5. Consideration Of Draft Change Order No. 4 To COF Contract No. 2017-0264 With Kiewit Infrastructure South Co, For The Water Reclamation Facility Modifications & Expansion Project.

Consideration Of Draft Change Order No. 4 To COF Contract No. 2017-0264 With Kiewit Infrastructure South Co, For The Water Reclamation Facility Modifications & Expansion Project.

The purpose of this memorandum is to provide information to the Franklin Board of Mayor and Aldermen (BOMA) concerning Change Order No. 4 for the Water Reclamation Facility Modifications & Expansion Project.

PROJECT: City of Franklin, Tennessee
Franklin WRF Modifications & Expansion Project

DESIGNED BY: J. LIND
CHECKED BY: B. SMITH
DATE: 07/15/15
PROJECT: FRANKLIN WRF MODIFICATIONS AND EXPANSION PROJECT
SHEET: M-17

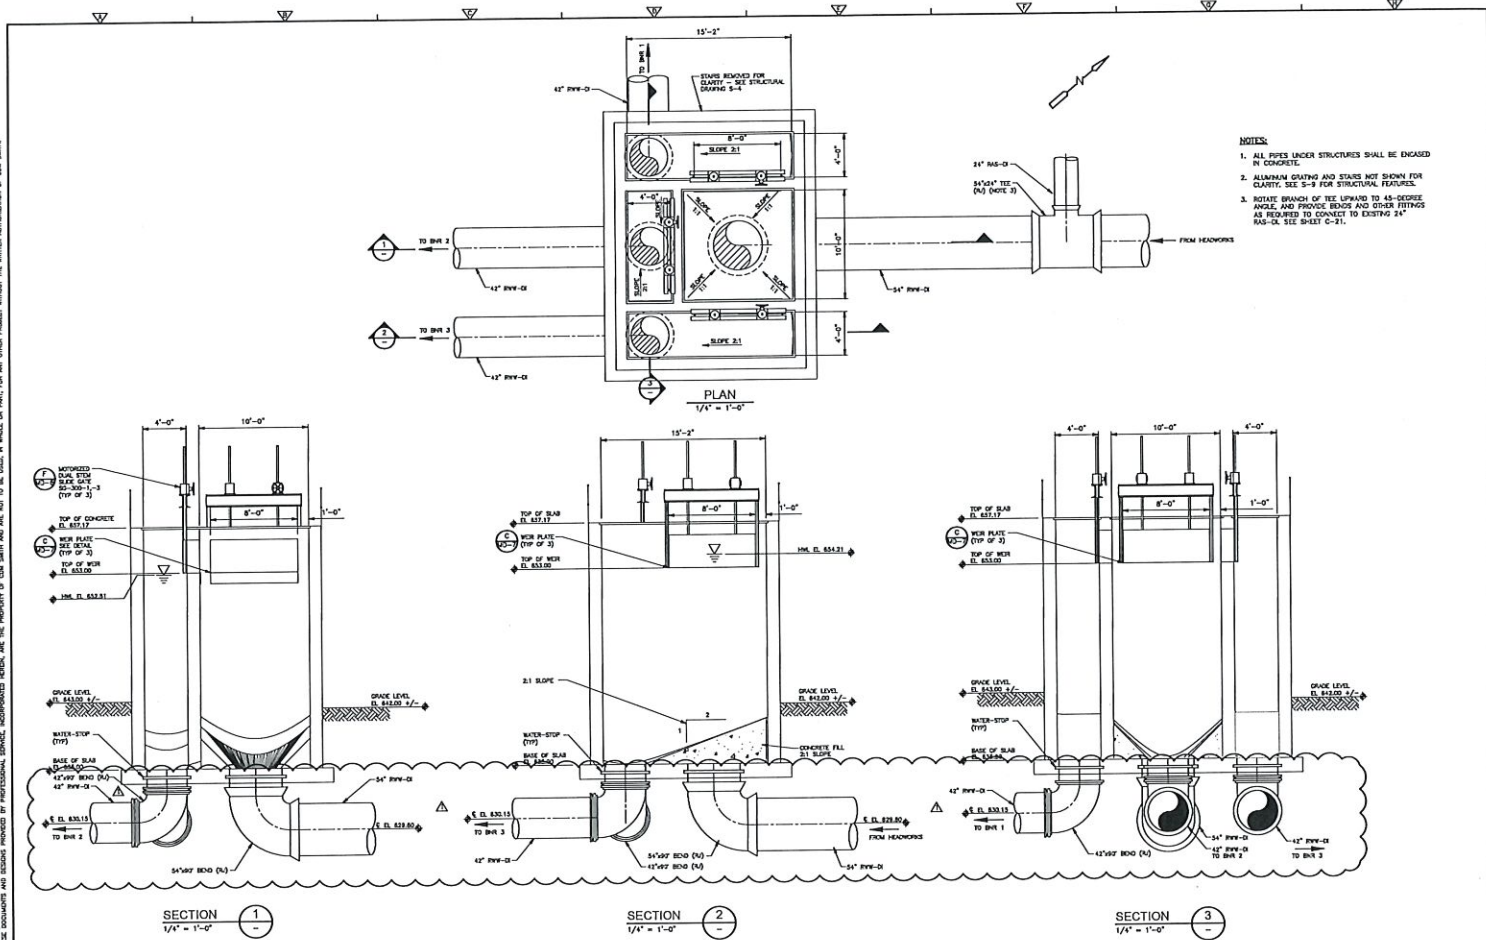
Kiewit has identified elevation differences on the drawings for the 42" RWW-DI lines leading from the future BNR Distribution Box to BNR Basins 1,2, and 3. On M-17, sections 1, 2, and 3 show each 42" line having a centerline at 627.03 leaving the BNR Distribution Box. On sheet C-52, profiles P14, P15, and P16 each show a 630.15 centerline at Station 0+00 at the BNR Distribution Box. On sheet M-21 and M-22, a typical section is referenced for the end of each 42" line on S-14. The typical section on S-14 shows the 42" line with a centerline at 641.00 at each BNR Basin, while the profiles on C-52 show each 42" Line ending with a centerline at 639.55.

DESCRIPTION: Per Engineer's response to RFI No. 124 (att.), revise yard piping elevations and profiles and finished grades as shown on revised sheets M-17, C-31 and C-52 (also att.).

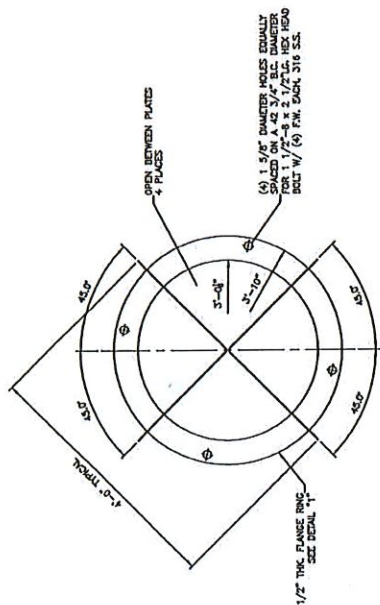
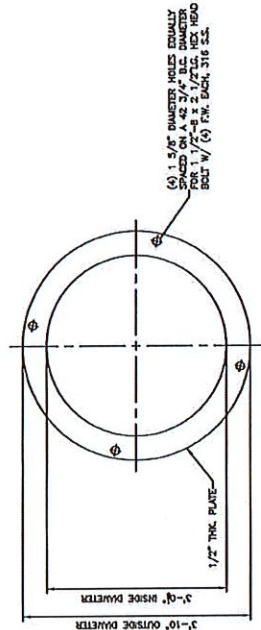
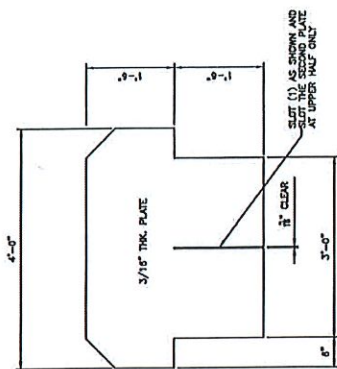
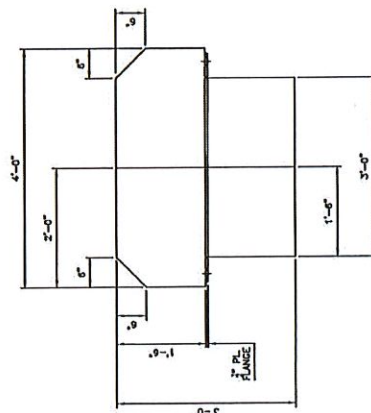
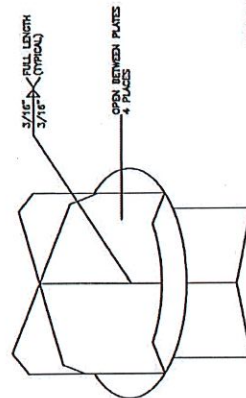
This letter is to address the engineer's comments on our drawing 11-05.5 which is a layout drawing of the engineer's drawing M-5. The 36" Flange x Flare castings are only made 24" long which with the top of flare elevation required being 659.19 would make the face of flange 657.19 and the bottom of the concrete floor 657.32. Not only does the .13 elevation difference does not leave room to assemble the flange x flare casting, but it also does not meet the design requirements. Our proposed solution would be to provide a 36"x01'10-7/16" DI CL53 Tapped FLG x PE w/wall collar 6" from face of flange. This would provide a flange at the bottom of the slab and a plain end to the required 659.19 elevation. Please let us know if this proposed solution would be acceptable.

Delete 36" flared castings (2 locations), replace with 36" FL x PE, add vortex breakers per the Engineer's response to RFI 101 and Fig. CCA-27.1.

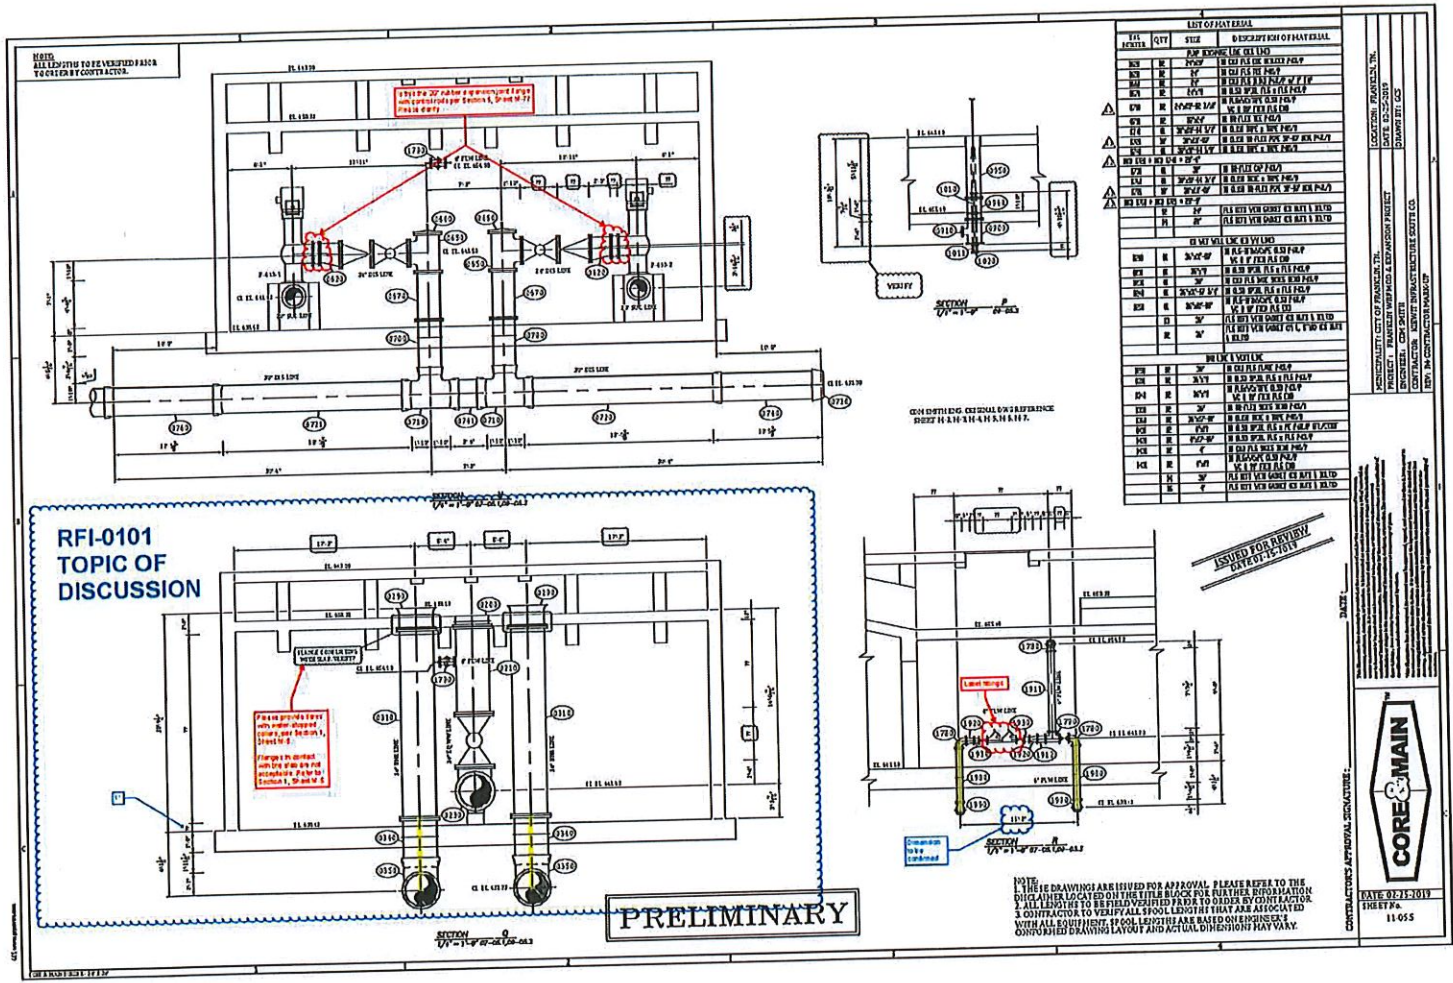
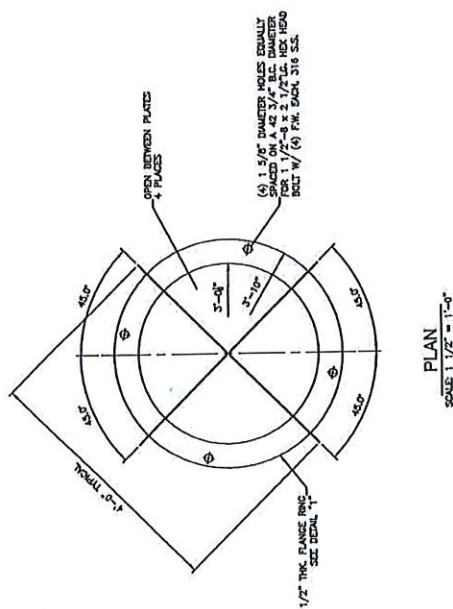
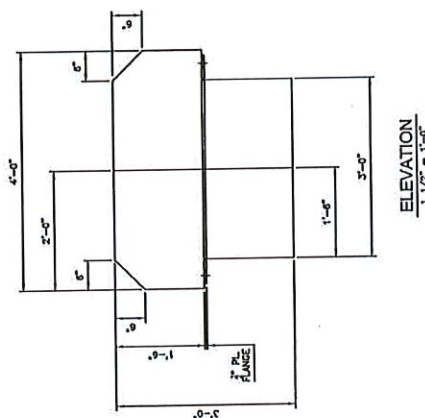
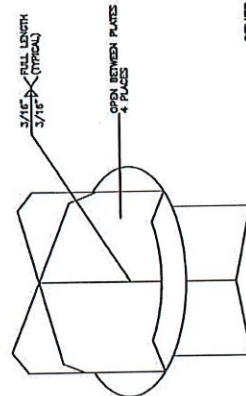
This letter is to address the engineer's comments on our drawing 11-05.5 which is a layout drawing of the engineer's drawing M-5. The 36" Flange x Flare castings are only made 24" long which with the top of flare elevation required being 659.19 would make the face of flange 657.19 and the bottom of the concrete floor 657.32. Not only does the .13 elevation difference does not leave room to assemble the flange x flare casting, but it also does not meet the design requirements. Our proposed solution would be to provide a 36"x01'10-7/16" DI CL53 Tapped FLG x PE w/wall collar 6" from face of flange. This would provide a flange at the bottom of the slab and a plain end to the required 659.19 elevation. Please let us know if this proposed solution would be acceptable.

Delete 36" flared castings (2 locations), replace with 36" FL x PE, add vortex breakers per the Engineer's response to RFI 101 and Fig. CCA-27.1.
